Access Compliance Report

Public Rights-of-Way

Intersection ID: 27847	Main Street: PARADISE RIDGE RD	Cross Street: NORTH COMMUNITY HOUSE RD	Location: NE
ADA ID: 710BC0173651	Ramp Type: ParaDiag	Initial Pass/Fail: Fail	Overall Compliance: No
Codes/Mitigation Info/Possible Solution		Field Measurements/Component Compliance	
Severity Score: 13.75

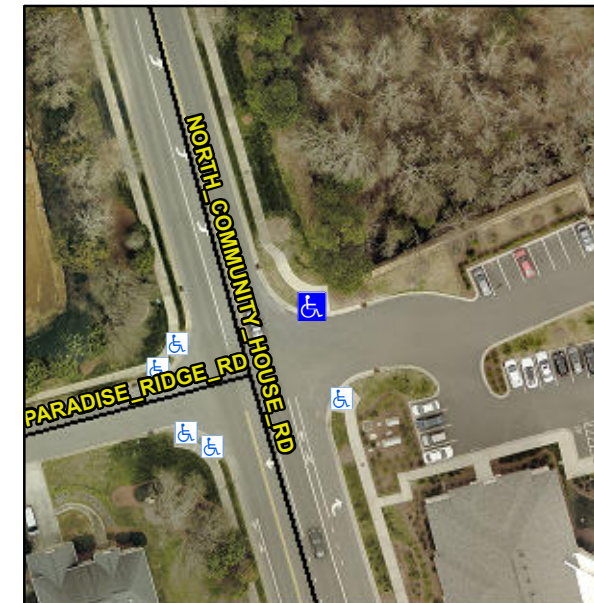
LT RP < 5%

R304.3.2, R304.5.3

Compliance	Description	Data	Compliance	Description	Data
N/A	Ramp Length LT (in)	28.0	N/A	Ramp Length RT (in)	50.0
Yes	Ramp Width LT (in)	167.0	Yes	Ramp Width RT (in)	167.0
Yes	Ramp Slope LT (%)	0.1	No	Ramp Slope RT (%)	11.1
Yes	Ramp XSlope LT (%)	1.9	No	Ramp XSlope RT (%)	2.7
N/A	Landing Length (in)	N/A	N/A	DWS Provided?	N/A
N/A	Landing Width (in)	N/A	N/A	DWS Contrast?	N/A
N/A	Landing Slope (%)	N/A	N/A	DWS Length (in)	N/A
N/A	Landing X Slope (%)	N/A	N/A	DWS Full Width?	N/A
N/A	Landing Curb? (Y/N)	N/A	N/A	DWS Offset (in)	N/A
N/A	Shared Landing?	N/A			
N/A	Gutter Ponding?	N/A	N/A	Gutter Slope (%)	N/A
N/A	Gutter Lip Ht (in)	N/A	N/A	Gutter X Slope (%)	N/A
N/A	Painted X Walk1?	No	N/A	Painted X Walk2?	No
	X Walk 1 Direction	To SW		X Walk 2 Direction	To SE
N/A	X Walk 1 Width (in)	N/A	N/A	X Walk 2 Width (in)	N/A
	X Walk 1 Slope (%)	2.7		X Walk 2 Slope (%)	1.5
	X Walk 1 X Slope (%)	2.3		X Walk 2 X Slope (%)	4.6
N/A	Ramp inside XWalk1?	N/A	N/A	Ramp inside XWalk2?	N/A

Remove & Replace Curb Ramp With Two New Directional Ramps or Equivalent.
